**RFB-2024-65**  
**SUNY SCCC CST BUILDING LOBBY AND BATHROOM RENOVATIONS**  
**C2 DESIGN GROUP**

**ADDENDUM #1**

Issued Date: 12/5/2024

Sheet Number:  
**E302**

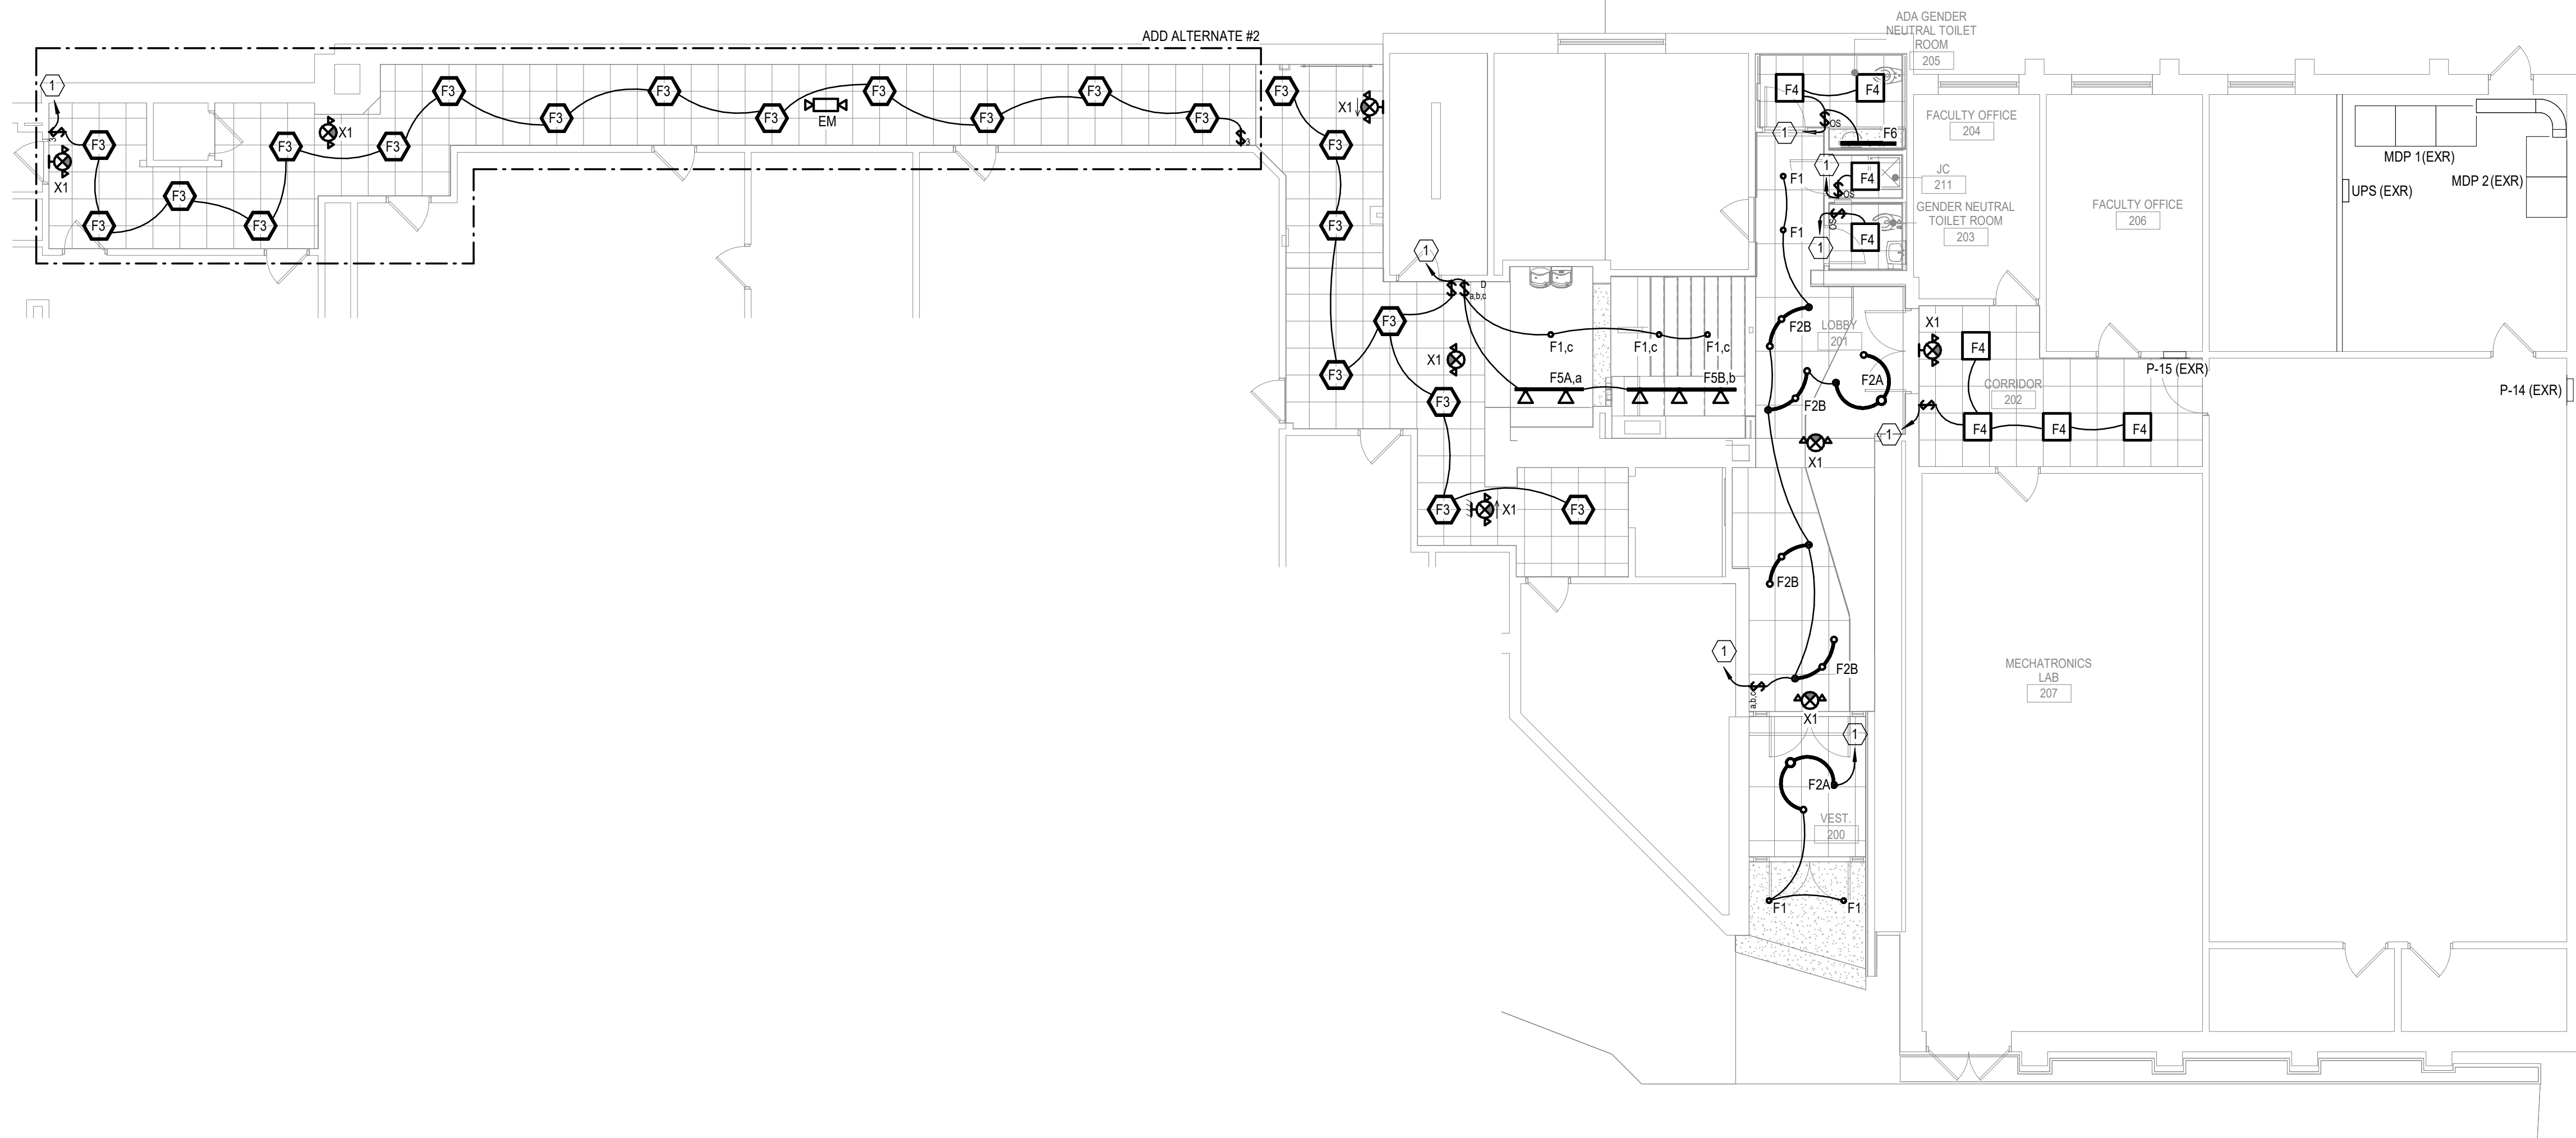
1. Drawing E302 – Lobby Level Electrical Removal Plans
  - a. Revisions as marked Addendum #1
2. Drawing E303 – Lobby Level Electrical Plans
  - a. Revisions as marked Addendum #1
3. Drawing D102 – Enlarged Demolition Plans
  - a. Revisions as marked Addendum #1
4. Drawing A103 – Enlarged Plans
  - a. Revisions as marked Addendum #1
